Revision 'C'

MARYLAND DOT - STATE HIGHWAY ADMINISTRATION
Office of Traffic & Safety
TRAFFIC ENGINEERING DESIGN DIVISION
(Traffic Signal Plan)

US 301 and Mitchellville/Queen Anne Bridge Road

DRAWN BY:	SPP	F.A.P. NO.	AC-STPG-000S(683)E	TS NO. 3524-C	SHEET NO.
CHECKED BY:	TMH/CJ	S.H.A. NO.	XX1005185		
SCALE:	1" = 20'	COUNTY:	Prince George's	T.I.M.S. NO. D565	1 OF 2
DATE:	2/21/00	LOG MILE:	16030121.31

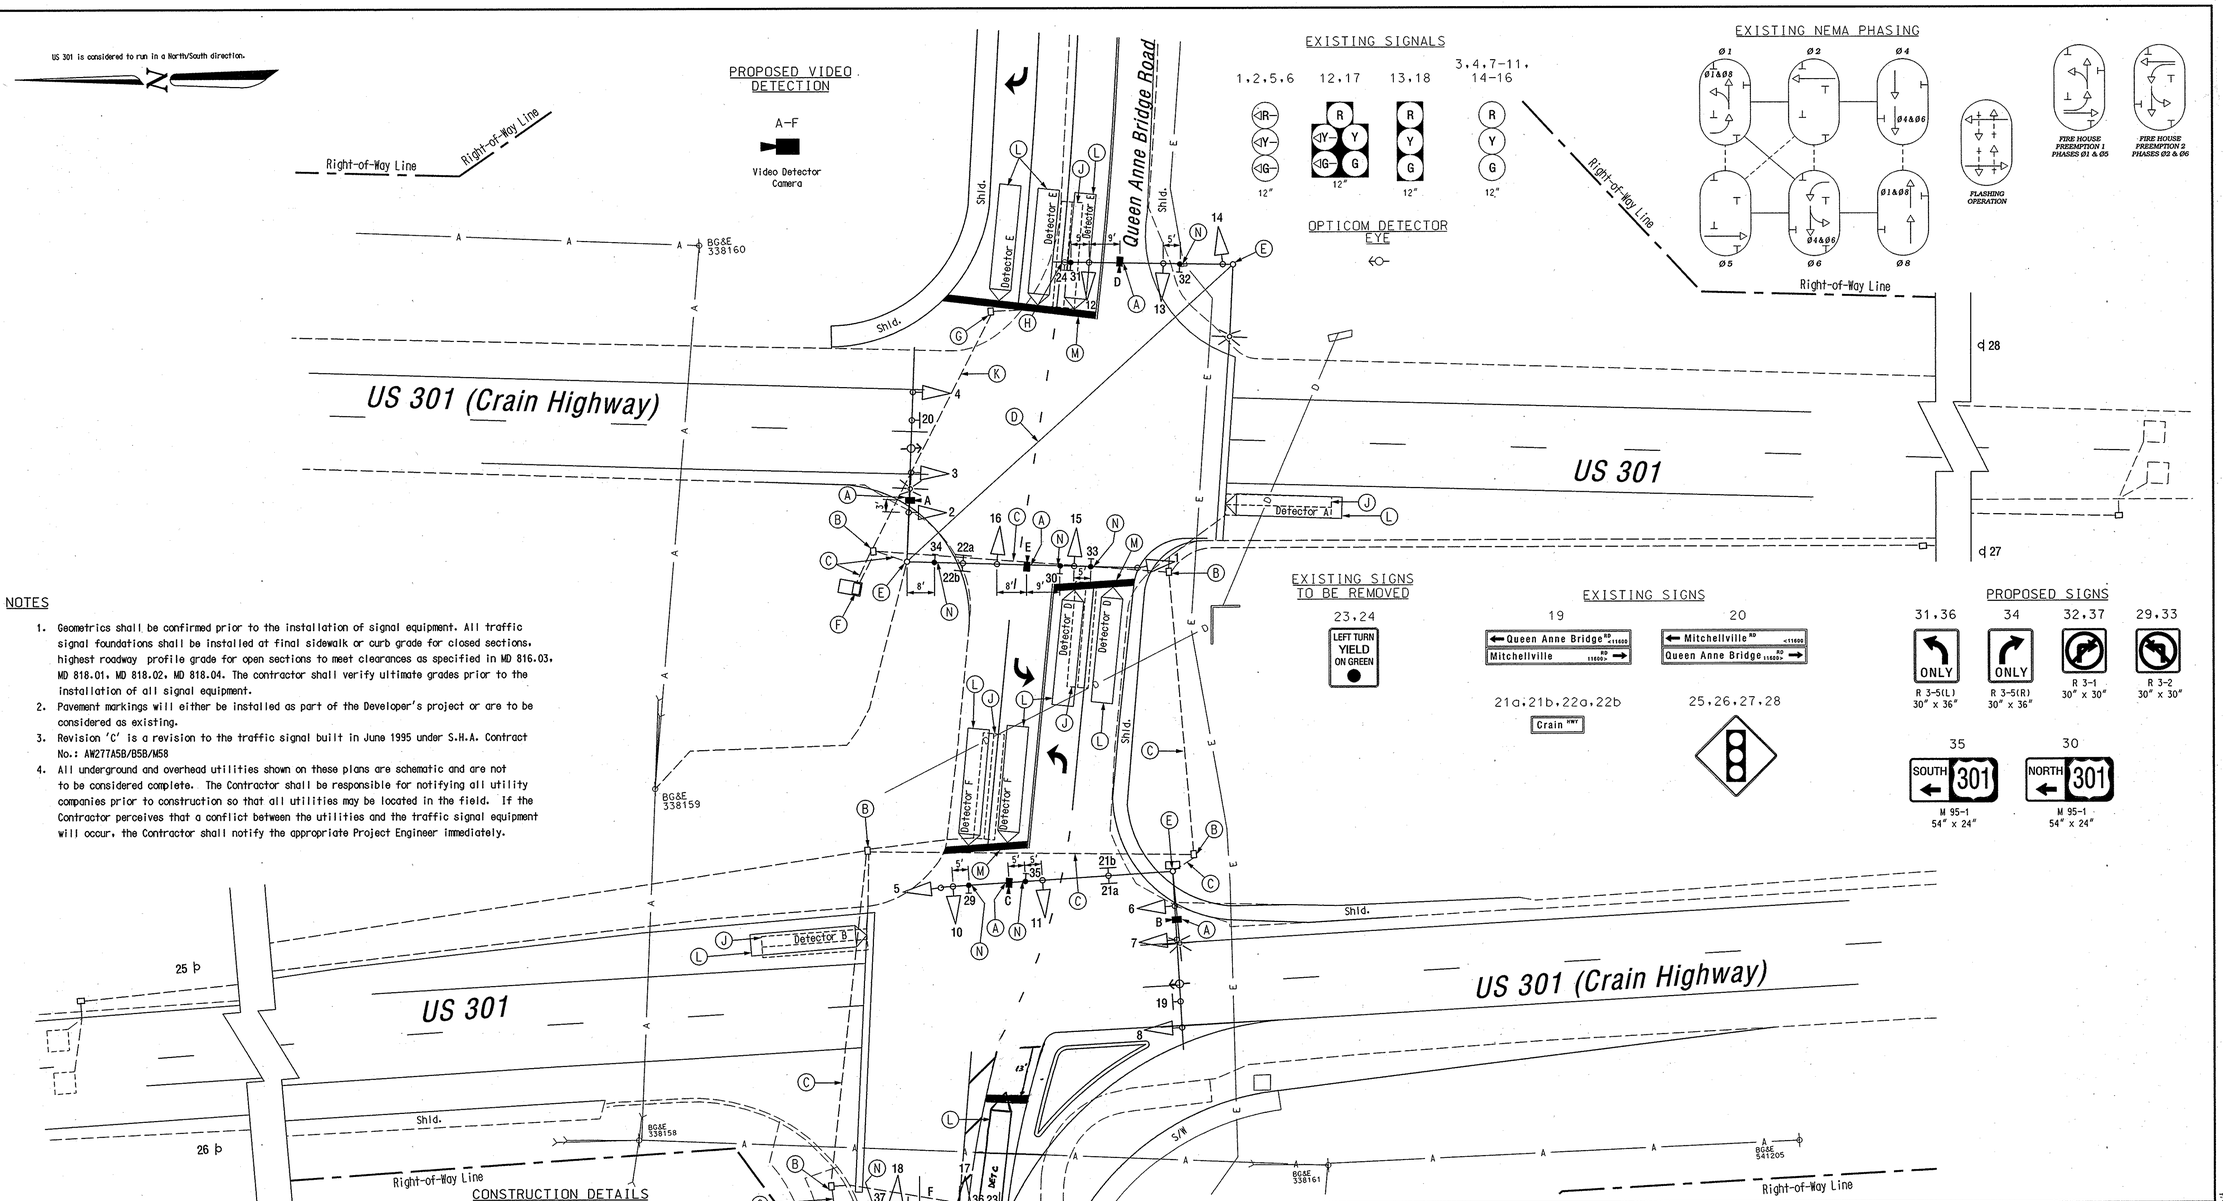
REVISIONS				
© Geometric change, replace loops with video detection cameras S.H.A. No.:BW996M82				07/05/06
FDB	CJS			2/00
B Install opticom detector eye NB US 301				
CEI				
A Change for ICB's to full signals				2/98
CJ	CJ	BRK	TH

A. Use exiting mast arm install video detection camera as shown.
B. Use existing handhole.
C. Use existing conduit.
D. Use existing span wire.
E. Use existing steel pole.
F. Use existing cabinet/controller and install video detection equipment.
G. Remove existing handhole
H. Remove existing R10-12 sign and install mast arm mounted R3-5(L) sign.
J. Abandon existing loop detector.
K. Cap and abandon existing conduit.
L. Proposed video detection zone
M. Proposed pavement markings to be installed by others.
N. Install mast arm mounted sign as shown.
